RE: Notice to Suspend and Intent to Terminate Contract for SW 2nd Avenue Median Parking, Invitation to Bid No.12278-693, Project No. 12434

NOTICE OF FINAL PUNCH LIST AND DEFECTIVE ITEMS

Project Name: SW 2nd Avenue Median Parking

FINAL SITE INSPECTION REPORT

CONSTRUCTION SET
 PROJECT # 12434
 SW 2ND AVENUE PARKING
 IMPROVEMENTS BETWEEN SW 32ND ST &
 SW 30TH ST
 PAVING GRADING & DRAINAGE PLAN

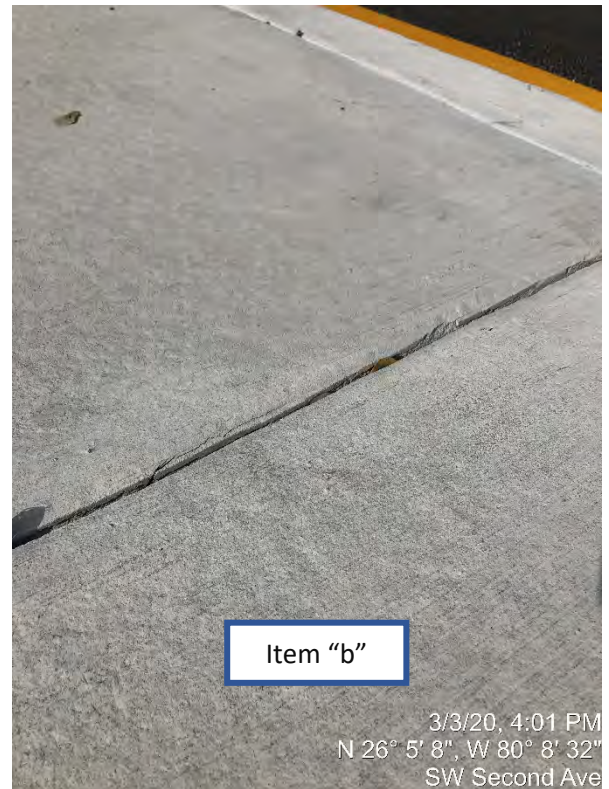
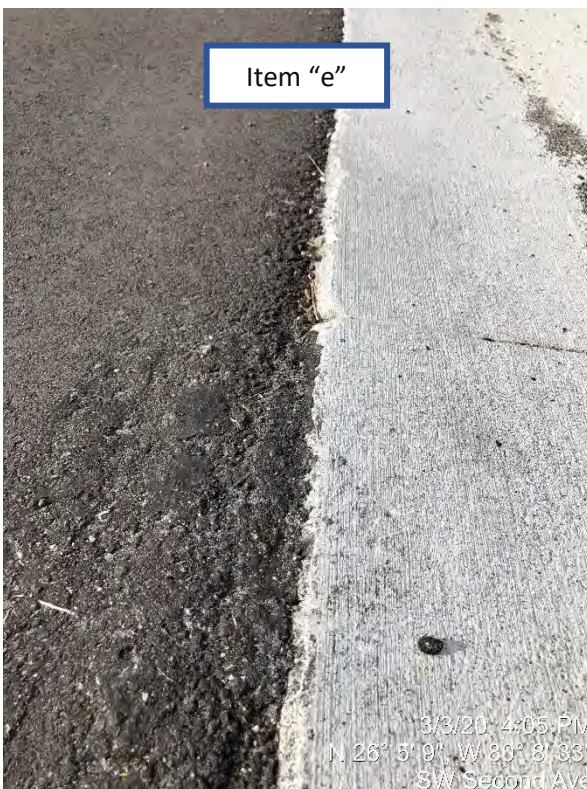
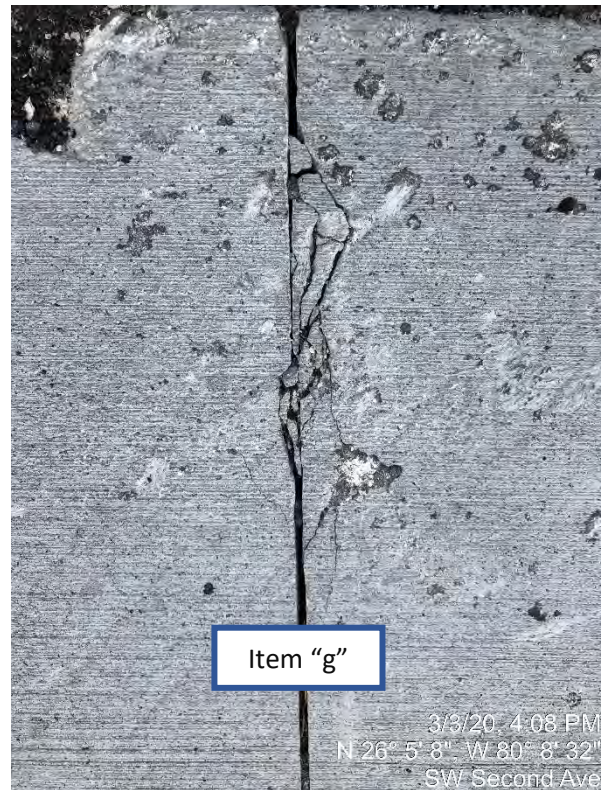
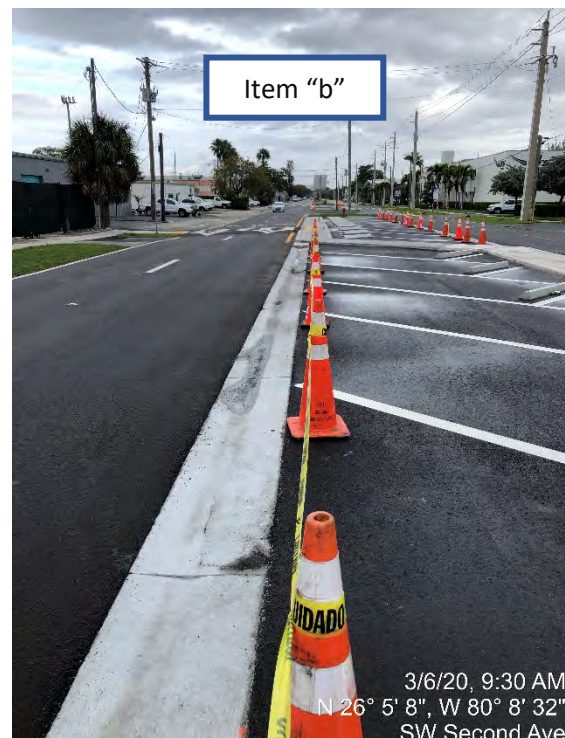
Median No. 1 (STA 25+05 – STA 26+30)

02771 – Concrete Curbs and Sidewalks

- a. Crack(s) recorded at Concrete Sidewalk STA 25+64 (4th joint North of ADA detectable warning surface).
- b. Crack(s) recorded at Concrete Sidewalk STA 25+69 (5th joint North of ADA detectable warning surface).

- c. Grinding of concrete at Valley Gutter STA 26+26 (North of catch basin No. 1 inlet).
- d. Crack(s) recorded at Valley Gutter STA 26+19 (South of catch basin No. 1 inlet).

- e. Deficient Valley Gutter Concrete/Asphalt interface STA 25+92 (3rd joint South of inlet of catch basin No. 1).
- f. Crack(s) recorded at Valley Gutter STA 25+39 (1st joint from South to North).

- g. Crack(s) recorded at Valley Gutter STA 25+49 (2nd joint from South to North).
- h. Joint missing and crack(s) recorded at Valley Gutter STA 25+30 (convergence of Valley Gutter and Type F Curb).

- i. Incorrect jointing pattern recorded on Concrete Sidewalk STA 25+25 to 26+33 (entire median).
- j. Ponding recorded on Concrete Sidewalk flags No. 1, No. 4, and No. 9 from North to South (STA 26+10, STA 25+95, and STA 25+35 respectively).

- k. Crack(s) recorded on curved portion of Type D Curb STA 25+05.

- a. Oil stains recorded on parking spaces No. 1, No. 2, and No. 8 from North to South STA 26+00 to STA 26+30, and STA 25+40.
- b. Ponding recorded on parking spaces No. 1, No. 2, No. 3, No. 4, and No. 8 from North to South (STA 26+25 to STA 25+85, and STA 25+30 respectively).
- c. CONTRACTOR failed to test for conformity with the specified grade after initial compression. Variance in surface more than 1/8-inch from the lower edge of a 12-foot straightedge recorded on parking space No. 8 from North to South STA 25+30.

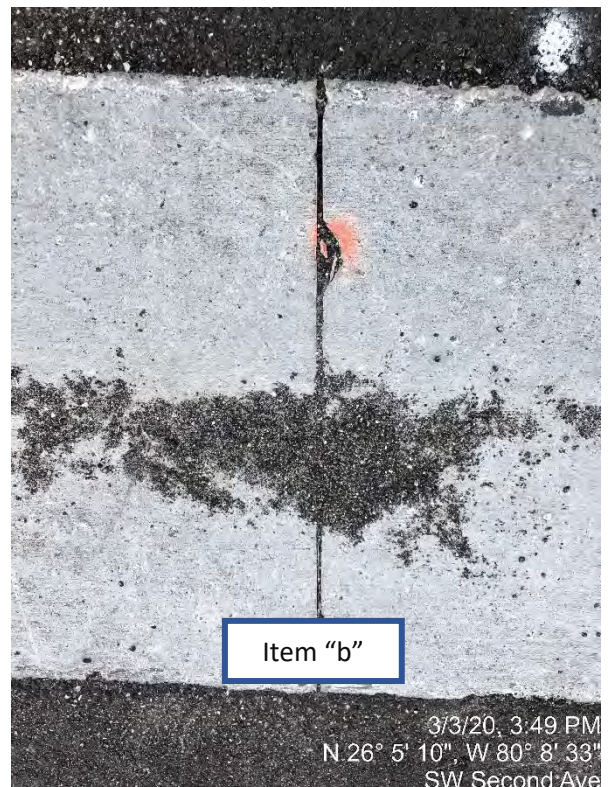
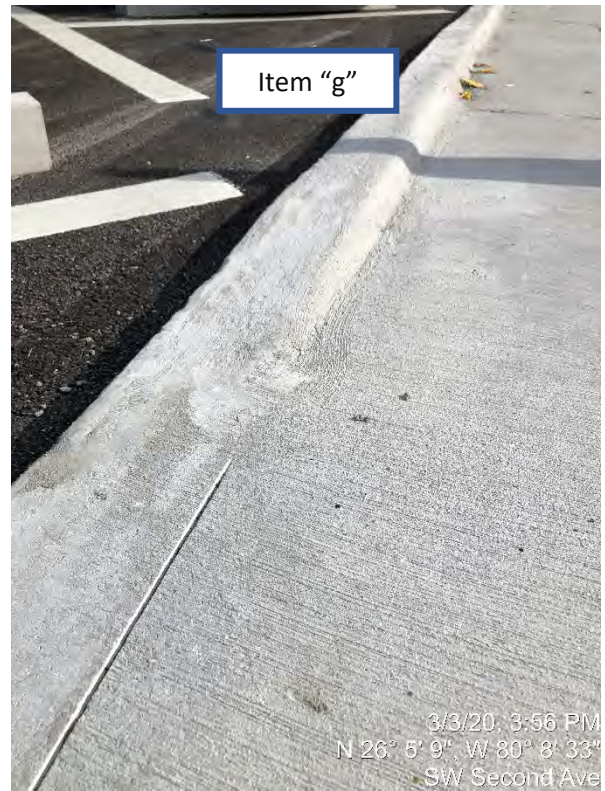
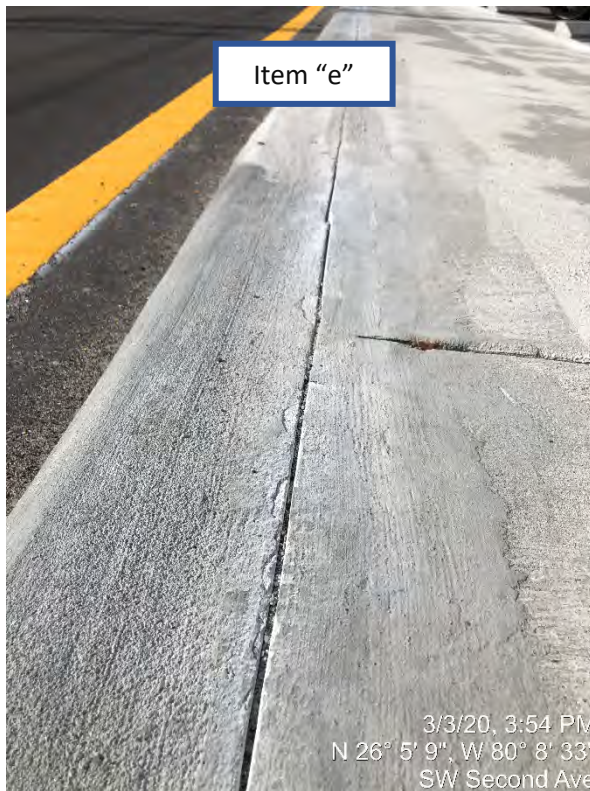
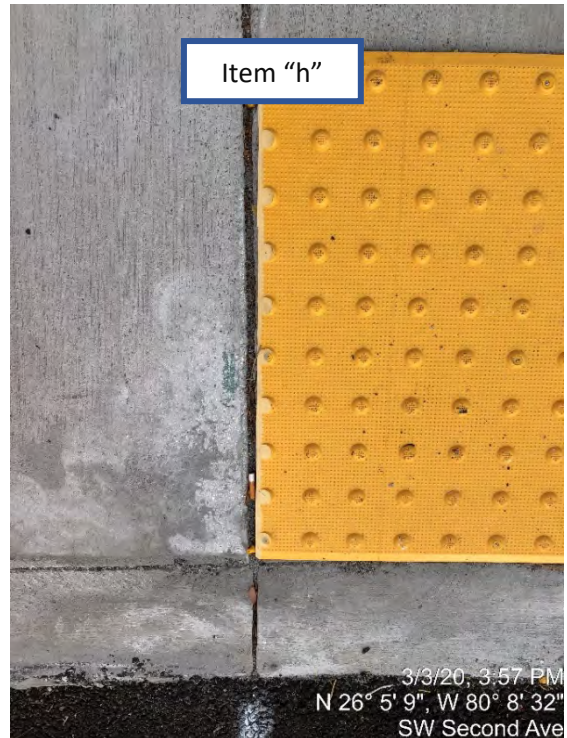
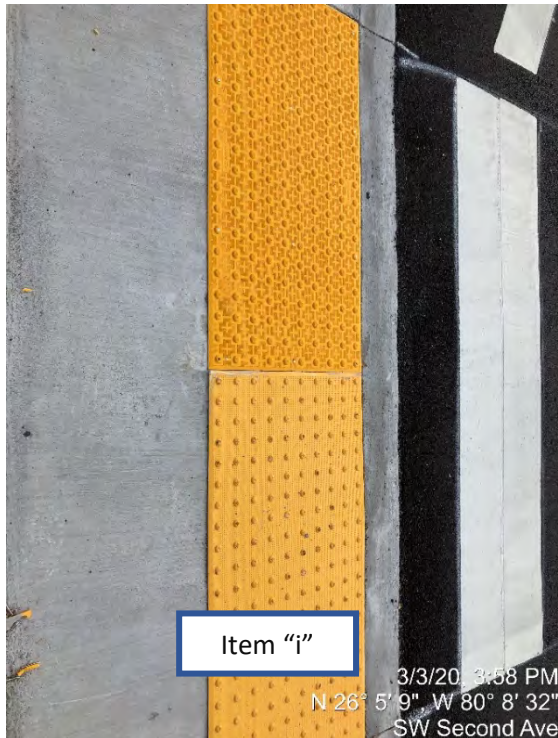
- a. Grinding of concrete at Valley Gutter STA 27+40 (convergence of Valley Gutter and Type F Curb).
- b. Crack(s) recorded at Valley Gutter STA 27+30 (1st joint from North to South).

- c. Concrete Wheel Stop damaged STA 26+49 (2nd from South to North).
- d. Concrete Wheel Stop inadequately installed 27+45 (1st from North to South).
- e. Repair method was not reviewed/approved by the City and it shows poor finish on Type D Curb STA 26+33 to STA 27+43. (deficiencies recorded at both sides of Concrete Sidewalk).

- f. Incorrect jointing pattern recorded on Concrete Sidewalk STA 26+33 to STA 27+43 (entire median).
- g. Expansion joint between Concrete Sidewalk and Type D Curb is interrupted at ADA accessible route ramp STA 26+62.

- h. Concrete grinding and/or poor finish on Concrete Sidewalk STA 26+67. (North and against detectable warning surface).
- i. Mismatch of detectable warning surfaces recorded STA 26+62.

- j. Ponding recorded on Valley Gutter STA 27+40 to STA 27+10. Low elevation grade at North end of Valley Gutter.
- k. Ponding recorded on Concrete Sidewalk flags No. 2, No. 3, and No. 5 from North to South (STA 27+35 to STA 27+25, and STA 27+15 respectively).

- l. Ponding recorded on Concrete Sidewalk behind detectable warning surface STA 26+63.
- m. Trip hazard between Type D Curb and Concrete Sidewalk STA 26+62.

- a. Ponding recorded behind Wheel Stops of parking spaces No. 2 and No. 8 from North to South STA 27+31 and STA 26+54 respectively.
- b. Ponding recorded on parking spaces No. 1 and No. 10 from North to South STA 27+39 and 26+33 respectively.

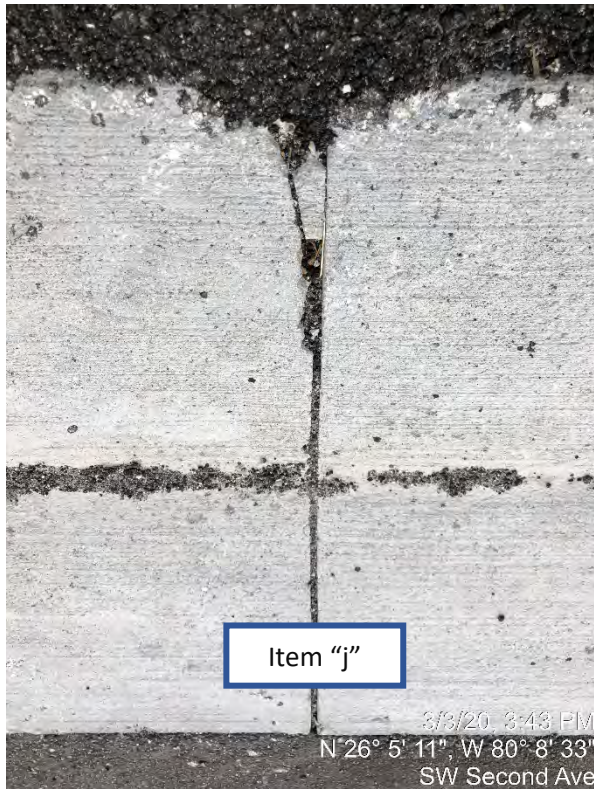
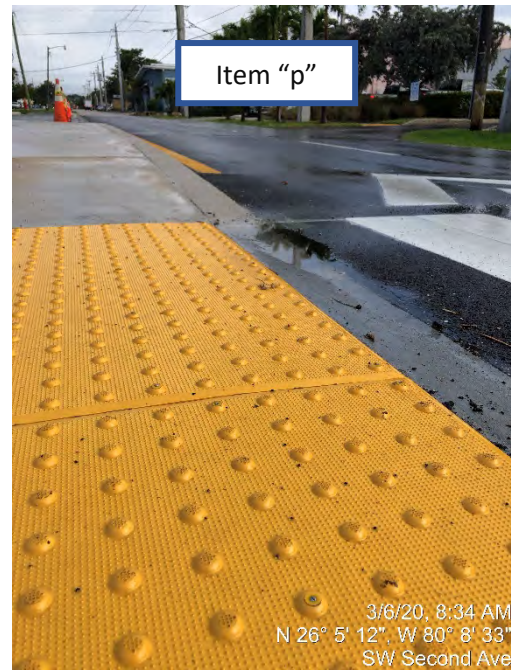
- a. Crack(s) recorded at Valley Gutter STA 29+82 (convergence of Valley Gutter and Type F Curb).
- b. Repair method was not reviewed/approved by the City and it shows poor finish on Type D Curb STA 29+66 to STA 29+85.

- c. Crack(s) repair method was not reviewed/approved by the City and it shows poor finish on Concrete Sidewalk STA 29+66.
- d. Repair method was not reviewed/approved by the City and it shows poor finish on Concrete Sidewalk STA 26+05 to STA 28+65.

- e. Expansion joint between Concrete Sidewalk and Type D Curb is interrupted at ADA accessible route ramp STA 29+31.
- f. Crack(s) repair method was not reviewed/approved by the City and it shows poor finish on Concrete Sidewalk STA 29+24 to STA 29+42 (ADA accessible route ramps and landing).

- g. Crack(s) recorded at Type F Curb STA 28+45 (two locations on the curved portion of the curb).
- h. Grinding of concrete recorded at catch basin No. 4 pad STA 28+62.

- i. Crack(s) and grinding recorded at Valley Gutter STA 28+76 (1st joint from South to North).
- j. Crack(s) recorded at Valley Gutter STA 28+85 (2nd joint from South to North).

- k. Incorrect jointing pattern recorded on Concrete Sidewalk STA 28+65 to STA 29+85 (entire median).
- l. Crack(s) recorded at Valley Gutter STA 29+82 (1st joint from North to South).

- m. Trip hazard between Type D Curb and Concrete Sidewalk STA 29+50.
- n. Expansion joints on curved portion of Type D Curb are irregular and not beveled.

- o. Ponding recorded throughout the Valley Gutter STA 28+67 to STA 29+54 and at STA 29+84 (North end). Low elevation grade recorded at both ends of Valley Gutter.

- p. Ponding recorded on Concrete Sidewalk behind detectable warning surface STA 29+34, and at flags No. 12 and No. 13 South of ADA accessible route ramp (STA 28+67 to STA 28+77).

- a. Ponding recorded on Concrete Sidewalk between medians III and IV (STA 29+65 to STA 29+84)
- b. Oil stains recorded on parking spaces No. 3, No. 6, and No. 7 from North to South (STA 29+43, STA 29+95, and STA 29+12 respectively).
- c. Ponding recorded on parking spaces No. 5, No. 6, No. 8, and No. 9 (STA 29+05 to STA 29+30, and STA 28+60 to STA 28+90).
- d. CONTRACTOR failed to test for conformity with the specified grade after initial compression. Variance in surface more than 1/8-inch from the lower edge of a 12-foot straightedge recorded on parking spaces No. 2, No. 6, and No. 8 from North to South STA 29+67, STA 29+06, and STA 28+88.

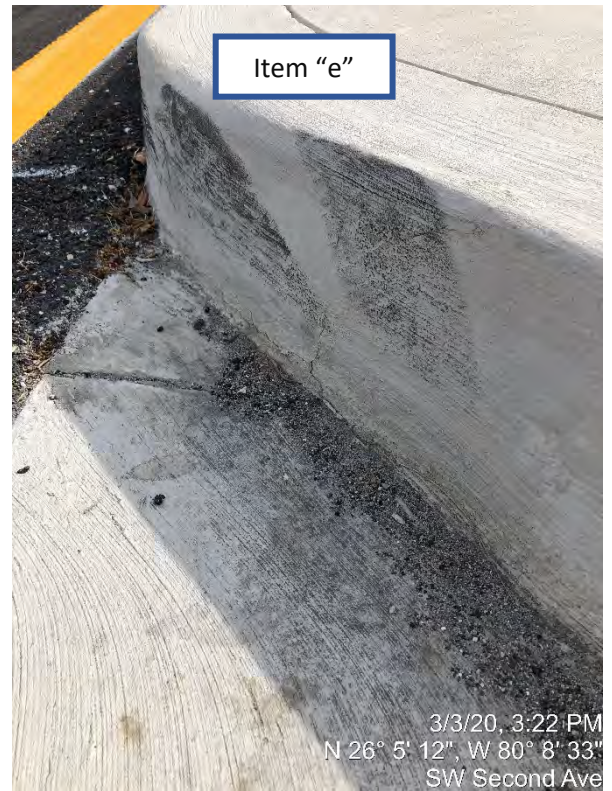
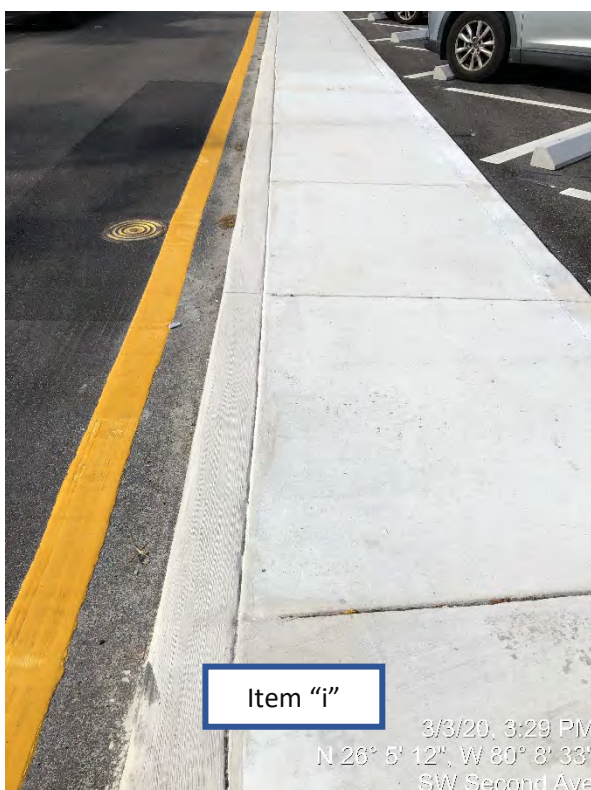
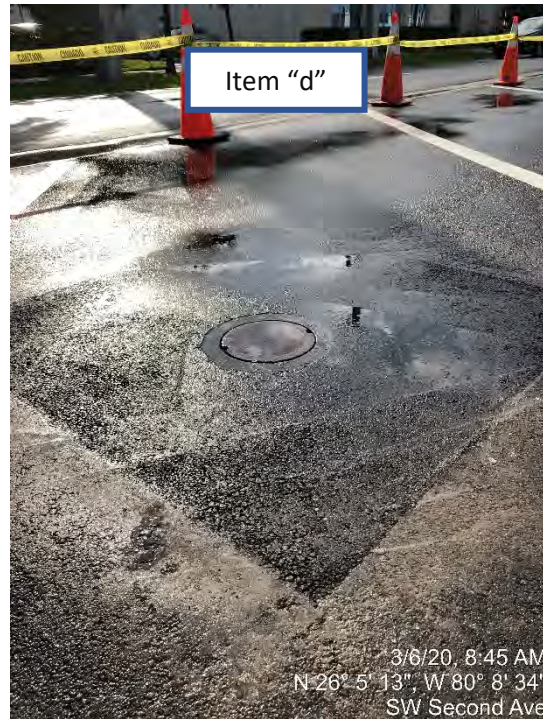
- a. Expansion joints on curved portion of Type D Curb are not beveled.
- b. Crack(s) recorded at Type D Curb STA 30+94 (West side of curb).
- c. Crack(s) and low elevation grade recorded on Type F Curb STA 30+83 (convergence of Valley Gutter and Type F Curb).

- d. Grinding of concrete at Valley Gutter STA 30+29 and STA 30+66
- e. Crack(s) and low elevation grade recorded at Valley Gutter STA 29+67 (beginning of Valley Gutter).

- f. Grinding of concrete at Sidewalk STA 30+82 (1st flag from North to South)
- g. Incorrect jointing pattern recorded on Concrete Sidewalk STA 29+85 to STA 30+85 (entire median).

- h. Crack(s) repair method was not reviewed/approved by the City and it shows poor finish on Type D Curb STA 29+85 to STA 30+65.
- i. Crack(s) repair method was not reviewed/approved by the City and it shows poor finish on Concrete Sidewalk and Type D Curb STA 29+88 (1st joint from South to North).

- j. Ponding recorded throughout the Valley Gutter STA 29+66 to STA 30+83. Low elevation grade recorded at both ends of Valley Gutter.
- k. Ponding recorded on Concrete Sidewalk behind detectable warning surface STA 30+71, and at flags No. 2, No. 7, No. 9, and No. 12 South of ADA accessible route ramp (STA 30+56, STA 30+24, 30+15, and STA 30+00 respectively).

- l. Trip hazard between Type D Curb and Concrete Sidewalk STA 30+71.

- a. Ponding recorded behind Wheel Stops of parking spaces No. 2 and No. 3 from North to South STA 30+58 to STA 30+76.
- b. Ponding recorded behind Wheel Stops of parking spaces No. 5 and No. 6 from North to South STA 30+22 to STA 30+45.
- c. Ponding recorded on SW 2nd Avenue Southbound lane STA 30+85.
- d. Ponding recorded on parking space No. 5 from North to South due to irregular asphalt patch surrounding gas valve STA 30+31.
- e. Ponding recorded on parking space No. 9 from North to South against Type D Curb STA 29+76.
- f. CONTRACTOR failed to test for conformity with the specified grade after initial compression. Variance in surface more than 1/8-inch from the lower edge of a 12-foot straightedge recorded on parking space No. 2 from North to South STA 30+68.

PROJECT # 12434
 SW 2ND AVENUE PARKING
 IMPROVEMENTS BETWEEN SW 32ND ST &
 SW 30TH ST
 PAVING GRADING & DRAINAGE PLAN

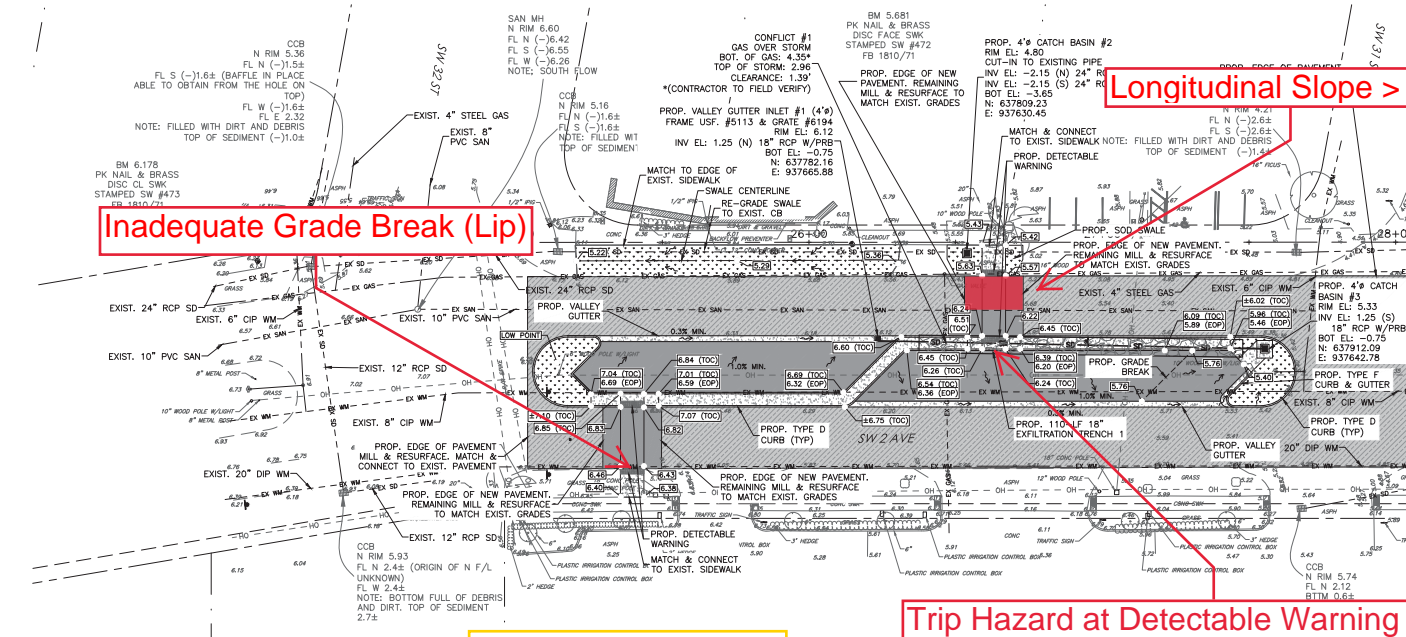
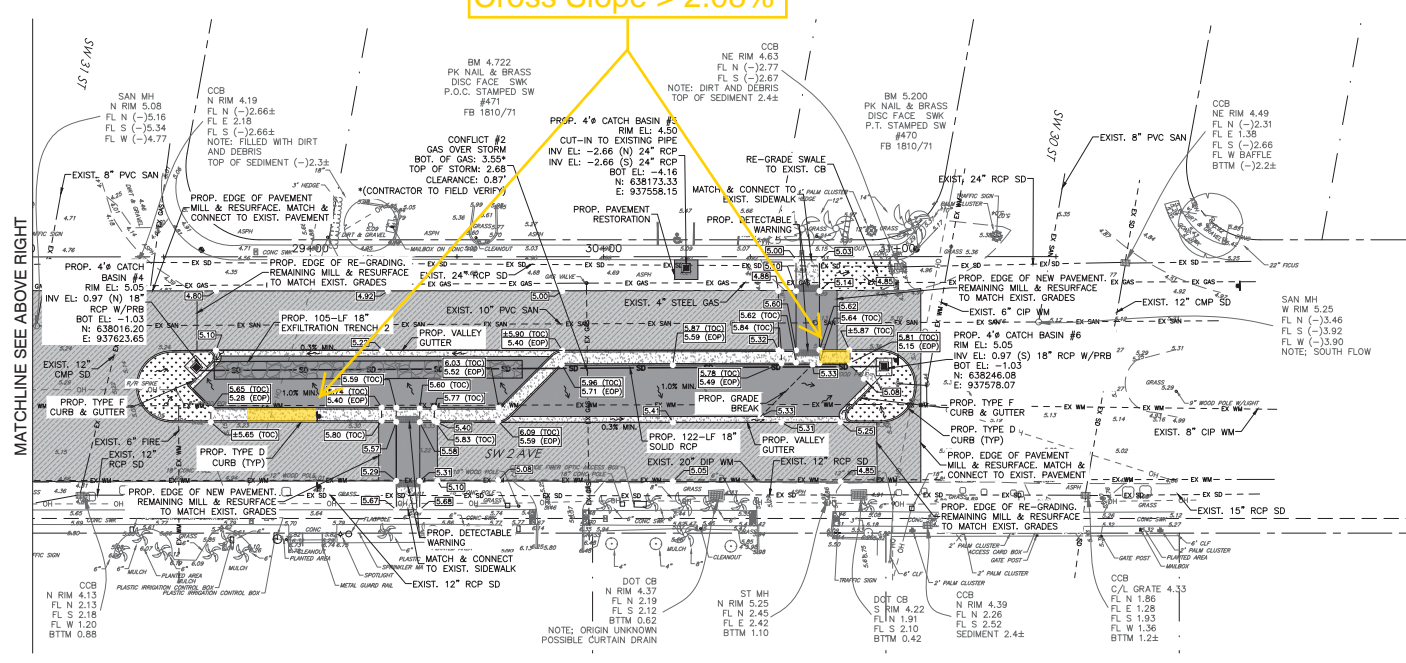
CONTRACTOR failed to comply with ADA cross slope of accessible routes walking surfaces requirements. The cross slope of walking surfaces shall not be steeper than 1:48 (2.08%). Portions of the sidewalk cross slope within the North median of SW 2nd Avenue were measured and recorded to be out of compliance.

Changes in level between ¼ inch and ½ inch shall be beveled with a slope not steeper than 1:2. CONTRACTOR failed to install detectable warning surfaces flushed with the abutting concrete sidewalks.

CONTRACTOR failed to comply with ADA running slope of accessible routes walking surfaces requirements. The running slope cannot exceed 1:20 (5%). The South raised crosswalk of SW 2nd Avenue Southbound right lane longitudinal slope is greater than 5%. The slope was measured at 7.5% - 8%, which represents a rise of approximately 9-inches in a 10-feet run.

Portions of accessible routes with running slopes steeper than 5% must be treated as ramps as prescribed in the ***United States Access Board Guideline – Chapter 4: Ramps and Curb Ramps***. Ramps running slope cannot exceed 1:12 (8.33%). Ramps must be equipped with handrails at both sides if rise is greater than 6 inches.

CONTRACTOR failed to provide adequate grade break or smooth transitioning between raised crosswalk and concrete sidewalk. Uneven surfaces were identified on the South raised crosswalk of SW 2nd Avenue Northbound right lane grade break with existing sidewalk. No lips or other variations in slope within runs are allowed, as they can disrupt wheelchair travel.

Portions of accessible routes with running slopes steeper than 5% must be treated as ramps. Handrails must be provided on both sides if rise is greater than 6"

Corrective actions shall be submitted and approved by the CITY before being performed. Grinding of the concrete surface is not acceptable as it may expose the concrete aggregates, compromising the durability of the structure.
